CITY OF COCONUT CREEK

DEVELOPMENT REVIEW COMMITTEE (DRC) REVIEW #5 – MARCH. 04, 2026

PROJECT NAME:	Al Hendrickson Toyota		
PROJECT NUMBER:	PZ-24030001		
LOCATION:	5201 W Sample Rd		
APPLICANT/AGENT:	Spring Engineering, Inc.		
REVIEW/APPLICATION:	PMDD Rezoning		
DISCIPLINE	REVIEWER	EMAIL	TELEPHONE
DRC Chair Resilient Design and Development	Deandrea Moise – Planning Manager	dmoise@coconutcreek.gov	(954) 973-6677
Resilient Design and Development	Liz Aguiar – Assistant Director	laguiar@coconutcreek.gov	(954) 973-6756
Sustainability & Photometrics Resilient Design and Development	Linda Whitman – Sustainability Manager	lwhitman@coconutcreek.gov	(954) 973-6756
Resilient Design and Development	Natacha Josiah - Planner	njiosiah@coconutcreek.gov	(954) 973-6756
Transportation	Michael Righetti - Senior Project Manager	mrighetti@coconutcreek.gov	(954) 973-6756
Building	Sean Flanagan - Deputy Building Official	sflanagan@coconutcreek.gov	(954) 973-6750
Engineering	Eileen Cabrera - Senior Engineer	ecabrera@coconutcreek.gov	(954) 973-6786

PARKING LEGEND	
	HANDICAP SPACES (12x18) = 5 SPACES + 2 EV
	STANDARD SPACES (9x18) = 270 SPACES
	EV CHARGING (10 9x18 & 2 HDGP) = 12 SPACES
	INVENTORY SPACES (9x18) = 369 SPACES
	PARKING GARAGE (9x18) = 568 SPACES
TOTAL PROVIDED PARKING = 1,224 SPACES + 6 BICYCLE SPACES

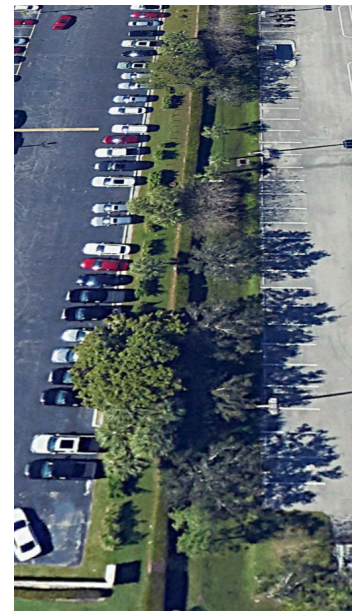
- n) **Table** – Revise table and add a line specific to the number of spaces provided in the parking garage. The “Parking Legend” on the next page breaks out the Parking Garage.
